PRAIRIE ISLAND NUCLEAR GENERATING PLANT
Docket Nos 50-282 License Nos DPR-42
50-306 DPR-60

Additional Information to Support the
License Amendment Request dated January 13, 1986

Additional Information to Support the
License Amendment Request dated January 13, 1986

FIGURE 1 Small Break Power Distribution Assumed for LOCA Analysis

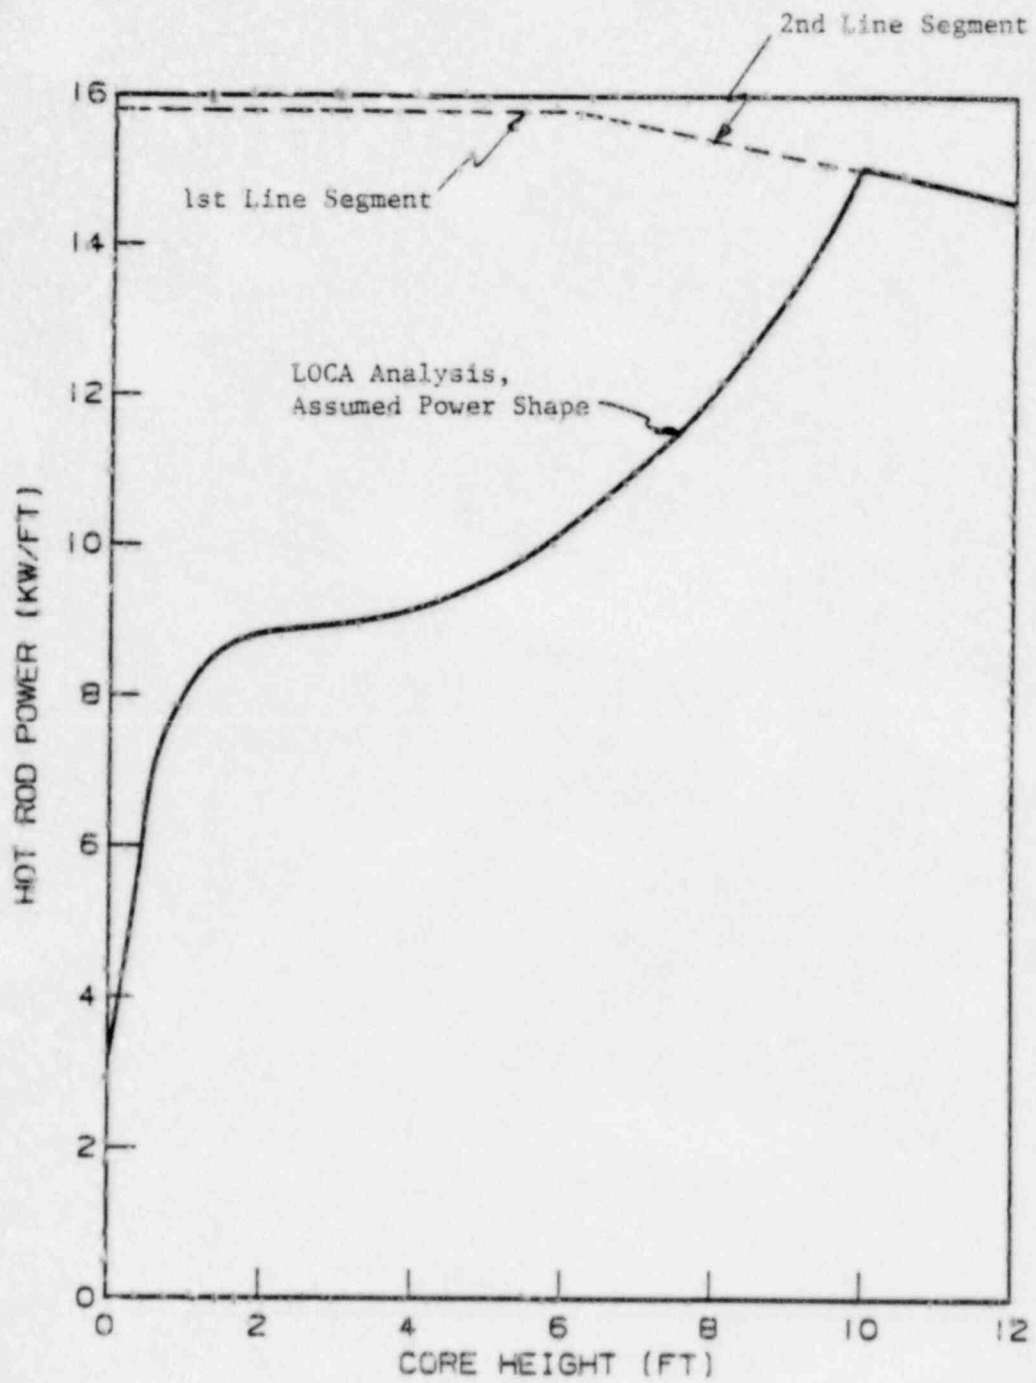
This license amendment proposes the elimination of the third line segment of the K(z) curve, Figure TS.3.10-5. K(z) is a normalized factor used to limit the power in the upper half of the core. The existing curve consists of three segments. The first segment is flat and has a value of one. The second segment has a slight negative slope. The third line segment has a large negative slope. The third line segment is based on the small break LOCA analyses. In the past, it was felt that power must be restricted below the third line segment to ensure that 2200°F cladding temperature was not exceeded during a small break LOCA.

The analyses submitted in Exhibit F and G clearly demonstrate that operation with power distributions up to the less restrictive second line segment are not close to the 2200°F limit. The power shape used for the small break LOCA analyses is shown as the solid line in the attached Figure 1. The K(z) restrictions were also plotted on this curve. Since the K(z) factor is a normalized function, a value of F_0 must be used in order to plot this curve on a plot of power density versus core height. The K(z) restrictions assume an F_0 of 2.5. Currently, an F_0 of 2.3 is being requested. The analyses assumed a value of 2.5 since future submittals are planned to be made which will support an F_0 of 2.5. The power shape used in the analyses summarized in Exhibits F and G is conservative for the value of F_0 proposed in this amendment. It should be noted that no operating modes have been postulated which would produce power shapes as extreme as the one used for these small break LOCA analyses. Therefore, these analyses justify the deletion of the third line segment of the K(z) curve.
